FOUNDATION INVESTIGATION REPORT  
By: Geocor, Limited.

Re: Proposed Widening Highway #401,  
C.N.R. Overpass - East of Steele St.,  
Downsview, Ont. - R.R. #30-60, Sta. 46.

ADDITIONAL REVIEW OF SOILS  
REPORT BY GEOCON, LTD.

Re: Allowable Bearing Capacity,  
Retaining Walls and Bridge Abutments,  
C.N.E. Overpass - East of Keele Street,  
W.P. 230-60, District No. 6.

FIGURE 2

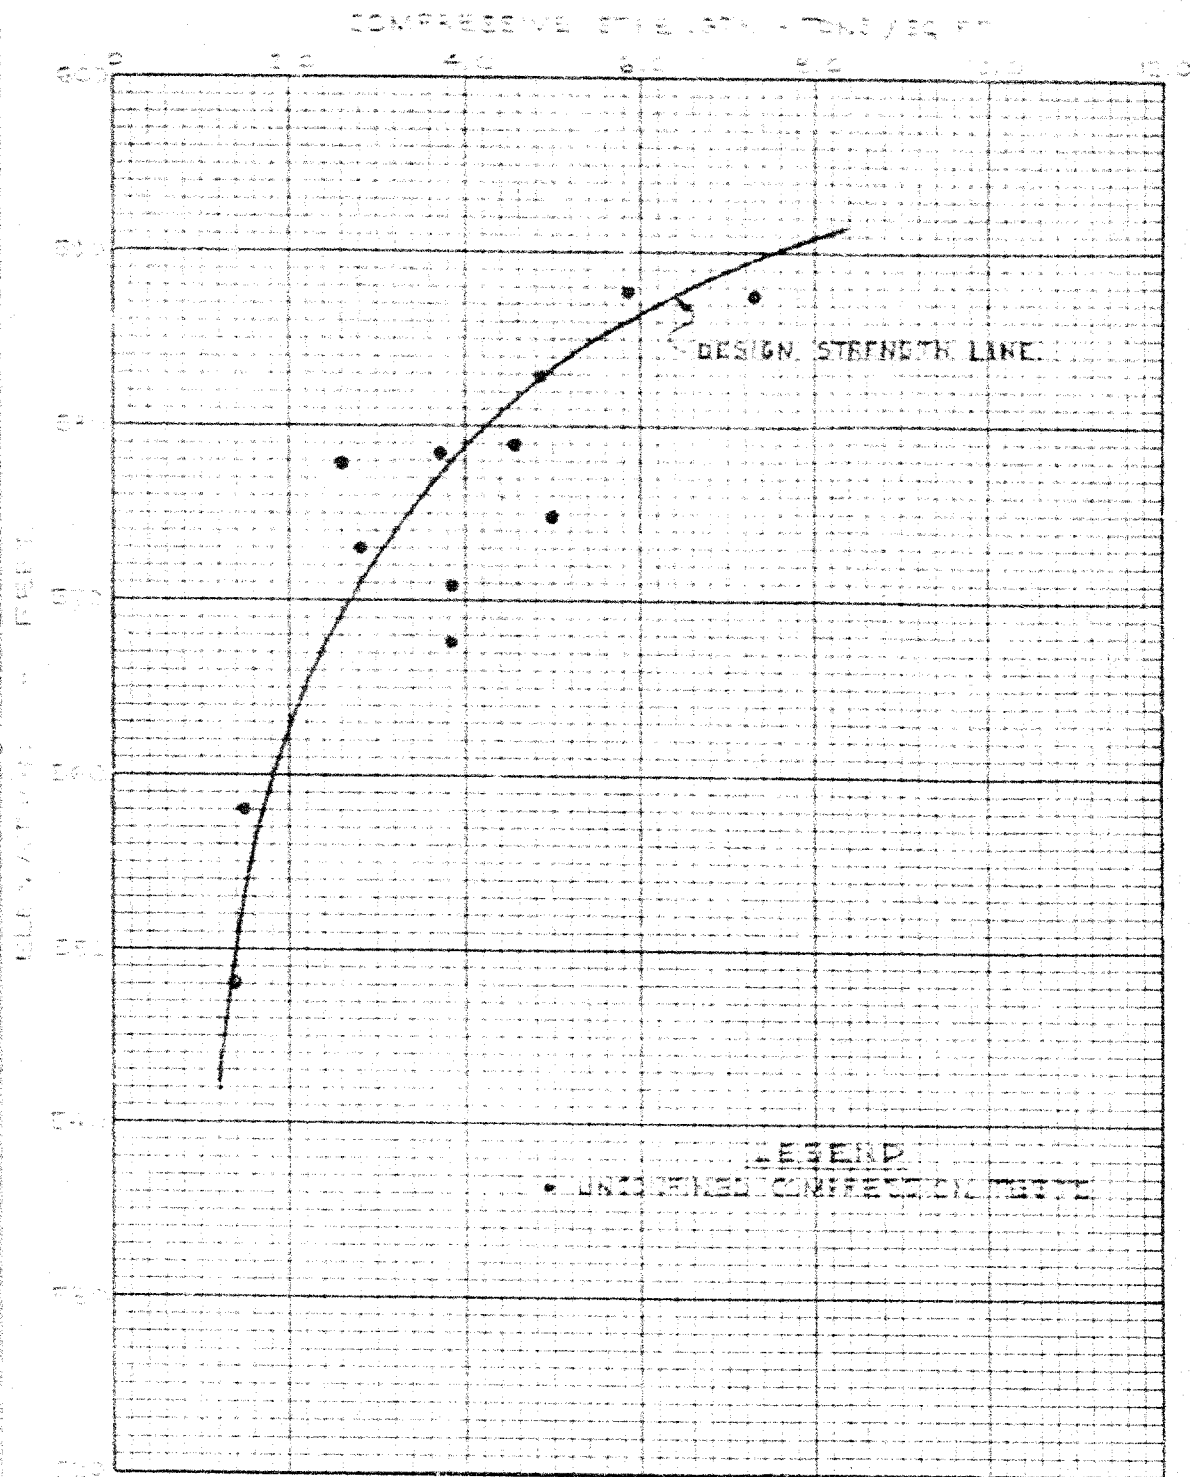
The above report was reviewed again and it was concluded that a sharp division of bearing capacities along a certain elevation is unjustified because the surface of the till layer is not horizontal. The proposed elevation of 590 is in places, even within the fill material and certainly 4.0 T/sq.ft. would not be allowable in such a material. It is therefore concluded that the footings should be placed on top of the dense till layer as it appears - i.e., the footings should follow the contours of this contact. The designer has followed this approach.

Further to our report S7350 dated April 24th, 1962 and our telephone conversation of May 18th, 1962, this letter discusses how the given allowable bearing values were determined and considers the possibility of increasing these values for footings founded within the compact to very dense silty till below elevation 590: Most of the footing length will be founded above elevation 590 at 4.0 tons per square foot, the maximum value generally allowed on the Toronto area tills. However, it is understood that considerable savings could be effected by any increase of the allowable bearing value for footings founded below elevation 590.

The results of the laboratory strength testing are plotted on Figure 2 of Appendix II in report S7350 in terms of compressive strength versus elevation and there appears to be a trend for a strength decrease with depth. The presence of a stiff crust and the colour change from brown to grey in the till, suggests that the higher strengths near the surface are due to desiccation.

With a design strength line as shown on Figure 2 of Appendix II, the allowable bearing capacity would depend on both footing elevation and width. In our report, we considered the more critical case of footings of the order of 20 to 25 feet, that is, very wide footings. A sophisticated analysis of bearing capacity

would ensure that on the basis of Boussinesq stress distribution, the available design strength below the footing was not exceeded at any depth. However, the strength of the till can not be determined accurately enough either in-situ or in the laboratory to justify this approach. The more approximate method, of the allowable bearing value equal to the average compressive strength for a depth below the footing equal to the width of the footing, was then used. Using this method and referring to Figure 2 of Appendix II the allowable bearing values for wide footings founded between elevation 580 and 590 would be from about 3 to 4 tons per square foot. The following tabulation gives the values obtained by this approximate method.

<u>Footing Elevation</u>	<u>Footing Width (ft.)</u>	<u>Allowable Bearing Value (tons/sq. ft.)</u>
590	10	4.0
"	20	4.0
"	30	4.0
585	10	4.0
"	20	3.7
"	30	3.2
580	10	3.5
"	20	2.9
"	30	2.6
